CITY OF ALLENTOWN

R3 – 2026

Certificate of Appropriateness for work in the Historic Districts:

**Historical Architectural Review Board
COA Preliminary Review Sheet**

Previous Condition (Applicant)

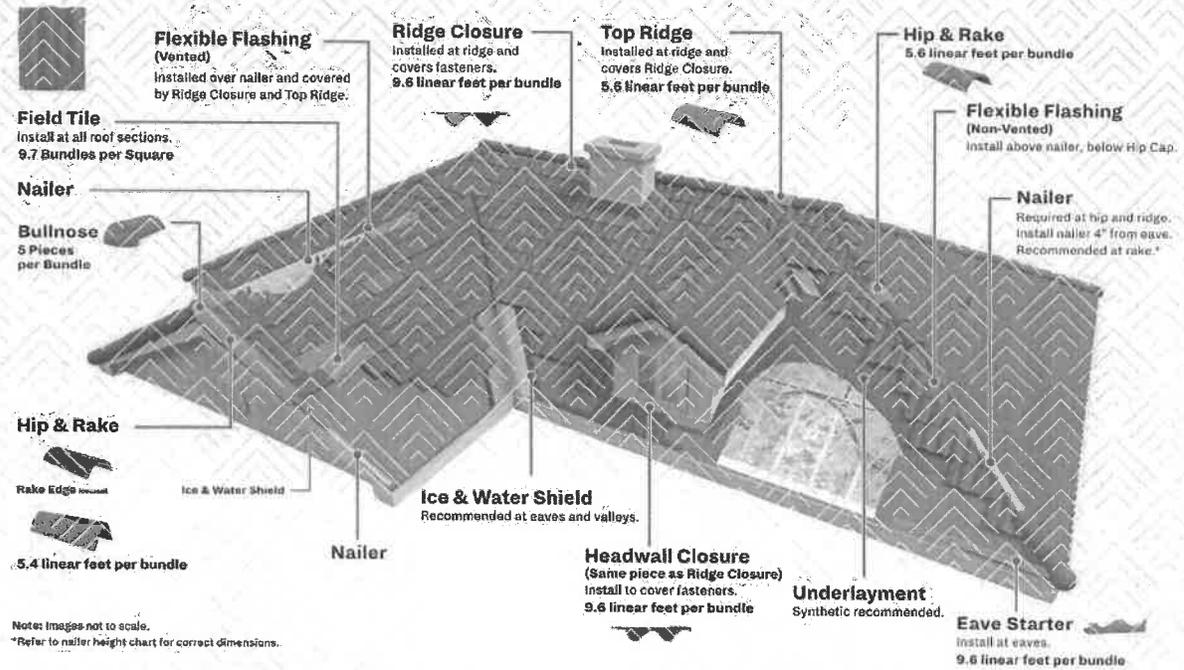
Observations & Comments: The original roof of 126-128 N 15 Street was Spanish barrel terra cotta clay tile. It appears that the original roofing materials have been completely removed at the main roof areas, and replacement with a red shake style architectural asphalt shingle was begun until work was stopped. The applicant has submitted an alternate material for review: Brava's Spanish Barrel Tile, a synthetic material that matches the original clay tile. This product appears to be an appropriate alternate material, as color options, profile, and appearance are consistent with the original historic clay. No specific color was proposed by the applicant. From the color chart, Antique Clay appears to be the closest match to the original clay; the applicant may obtain samples and submit photos to Staff showing the sample and the remaining original tile for final color selection.

The application does not indicate if the original clay tile at the projecting eaves at the first floor and the gable ends are intended to remain or be replaced with the other roof areas. If these areas are in sound condition, they should be

- The original clay tile at the projecting eaves at the first floor and gable ends are maintained and not replaced
- Proposed changes to any other roof-related elements such as gutters or downspouts are submitted in a separate application.
- Final color is approved by Staff

- Samples of the barrel configuration with colors closest to the existing color is submitted to staff for color approval. Photos submitted should show the samples next to the existing/original clay roof tile.
- The hips, rakes, and ridges are consistent in design throughout the roof and submitted to staff for approval.
- Detail for valleys to be submitted to staff for approval; if valleys are open they are to be copper, or the valleys can be closed as suggested in the manufacturer's documentations.
- The existing gutters and downspouts are maintained.
- If there are any other changes to roof components, a separate application will be made.

Proposed Material (Applicant)

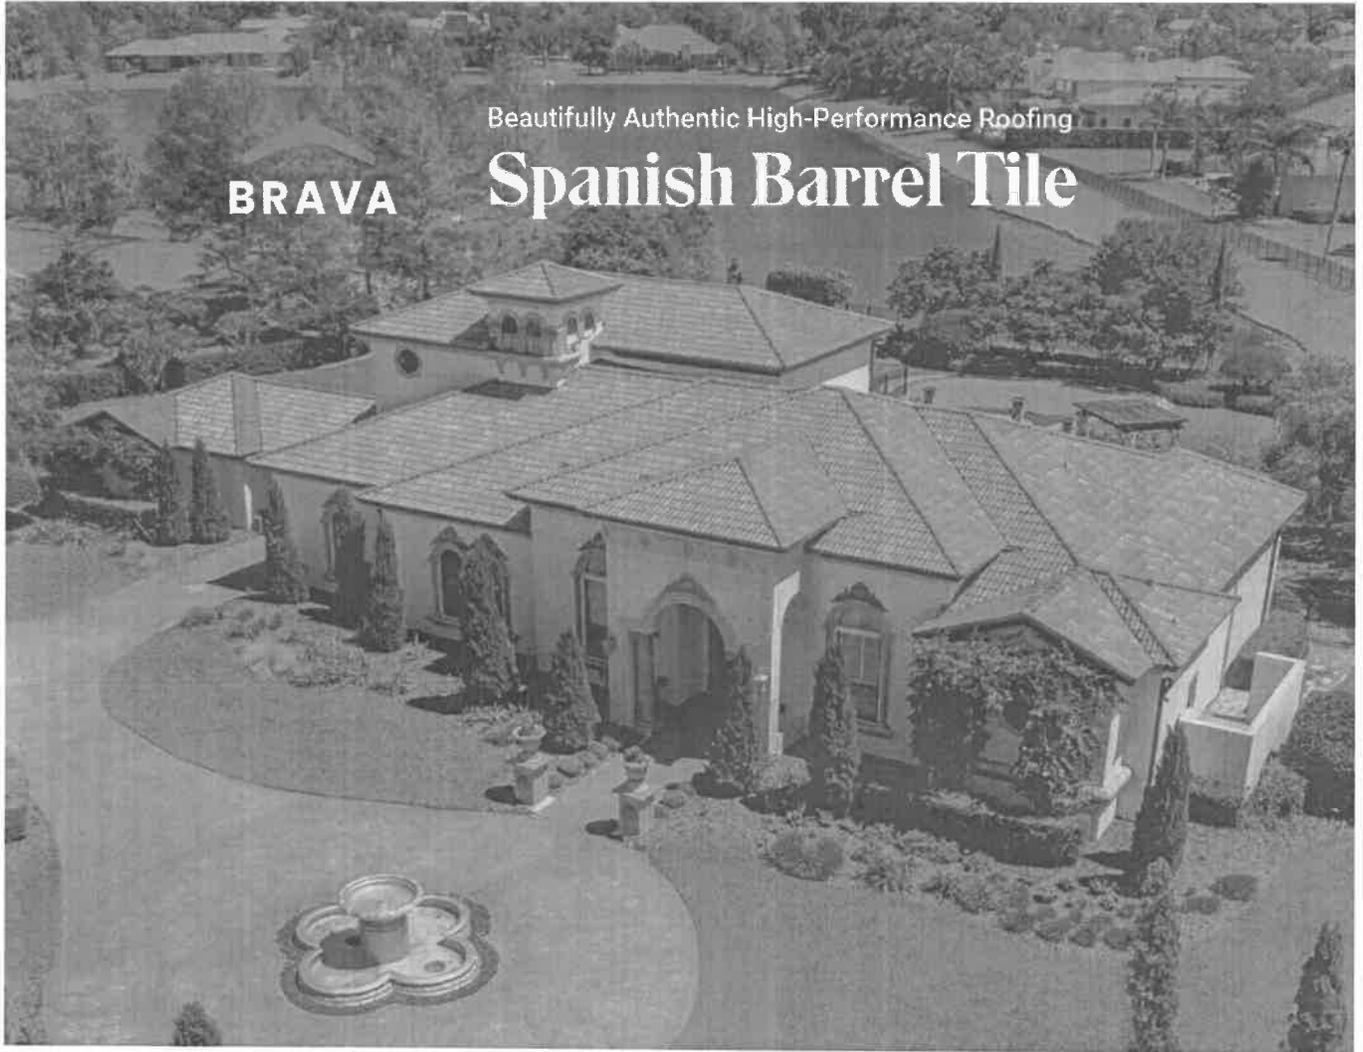
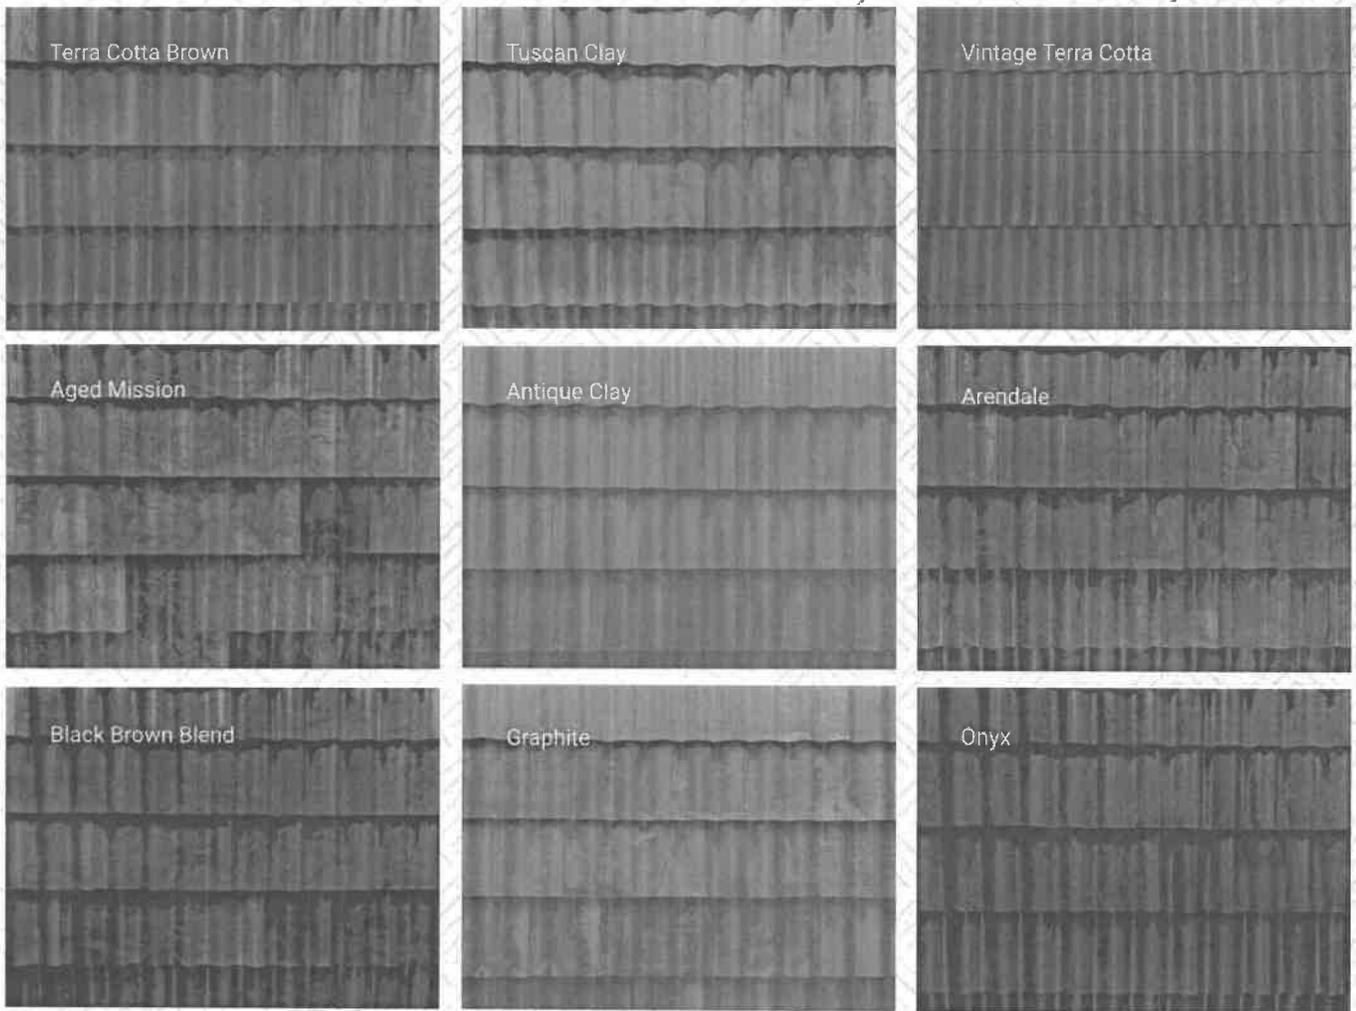
The Board discussed roof detail areas, including hips, rakes, and ridges. Mr. Knee noted that these elements should be consistent across the roof. Mr. Hart noted that those elements are included in the manufacturer's product information. The applicant stated that all elements for the roof will be from the same manufacturer. Mr. Huber noted that the original valleys appeared to be open and copper. The applicant was unsure how the roofer would be detailing the valleys. The Board discussed that multiple approaches can be included in conditions. Mr. Knee noted that the valleys could be open or closed. Mr. Huber expressed that if the valleys were open, they should be copper to stay in keeping with the original material.

Original Panel Design (Applicant)

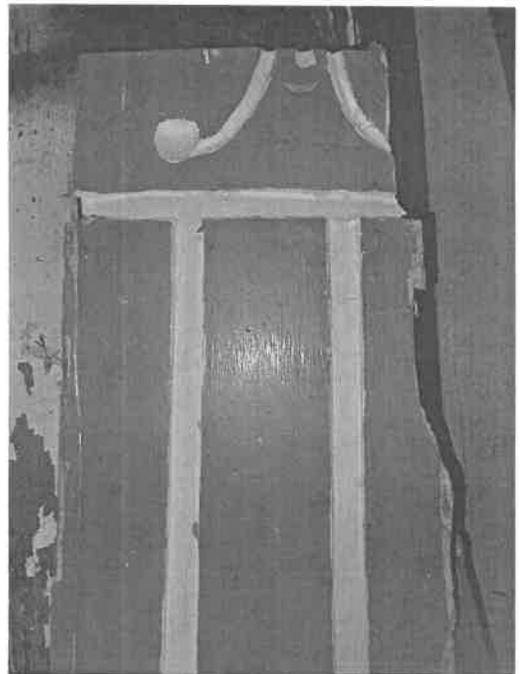
Observations & Comments: The applicant offered a descriptive approach to the treatment of deteriorated wood elements at window panels and soffits. The photographs submitted focus on the second-floor projecting bay window. More information would be helpful to understand the extent of the work area- i.e., confirming that the work only at the second-floor projecting bay window, or if other areas of the façade are included. Generally, it is appropriate for the exterior face of the wood trim to be scribed to match the original wood trim detailing. All wood surfaces should be painted.

The proposed scope calls for adding new scribed trim onto replaced substrate. Based on the submitted photos, it appears that replacement wood is in plane with original scribed trim. More information would be helpful to understand how a consistent finished plane will be achieved; ensuring that edges align appropriately to adjacent elements, such as other trim and window sills.

Staff Recommendation: Staff request more information on the extent of the work area and the approach for achieving a consistent plane of the trim's surface. Generally, the proposed approach to replacing the wood trim is appropriate. All exposed wood surfaces should be painted.

- Wood trim replacement material would be cedar, cypress, or mahogany. Final material to be submitted to staff
